Subject: EPA Comments on “Draft Coal Combustion Residue Impoundment: Round 12 – Dam Assessment Report – Wisconsin Public Service Corp – Weston, Rothschild, WI”

Draft Coal Combustion Residue Impoundment
Round 12 - Dam Assessment Report, Weston Generating Station

Comments on the Draft Coal Combustion Residue Impoundment

Weston Generating Station (Site 26)

Flood Zone / Inundation Map - Weston Generating Station

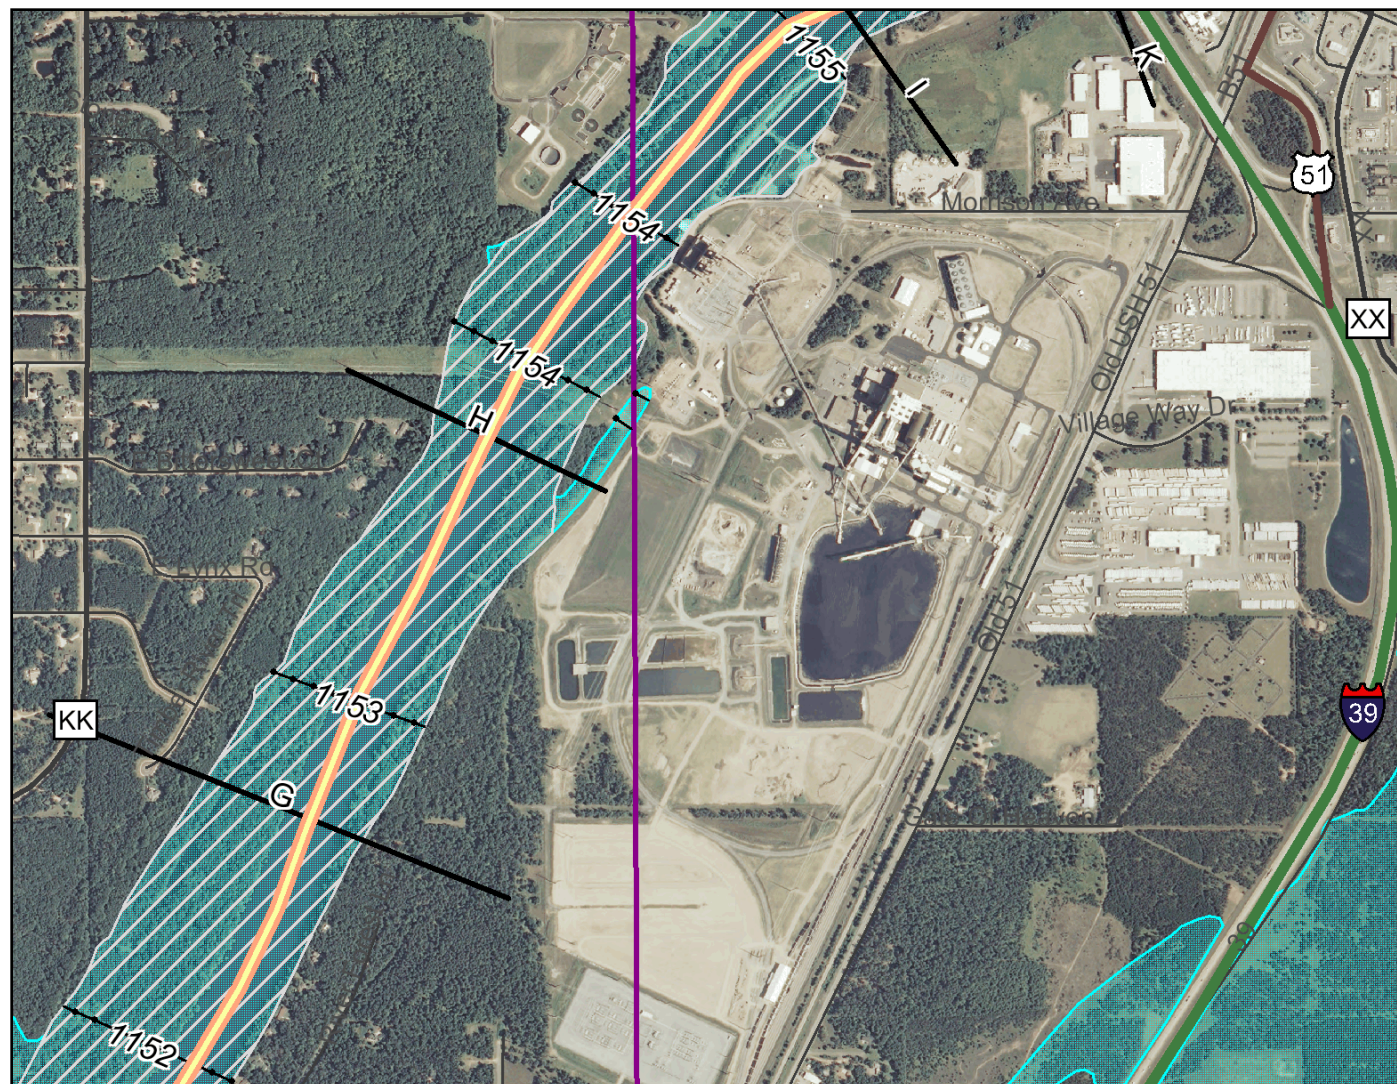
1. Page 6-1, section 6.1.1, Flood of Record. WPSC provided Figure 1 of this attachment as part of the August 2012 inspection depicting the location of the flood plain relative to the management units. The map shows the 100 year flood and 500 year flood plain areas near the facility³.
2. Page 6-1, section 6.1.2 Inflow Design Flood. This is not applicable as the management units are not subject to river flows and inflow to the management units is controlled by the facility. Consequently, the only hydrologic effect that could potentially impact the basin is a rain event. As provided above, the basins are operated with sufficient freeboard to contain rainfall from a 100 year rain event.
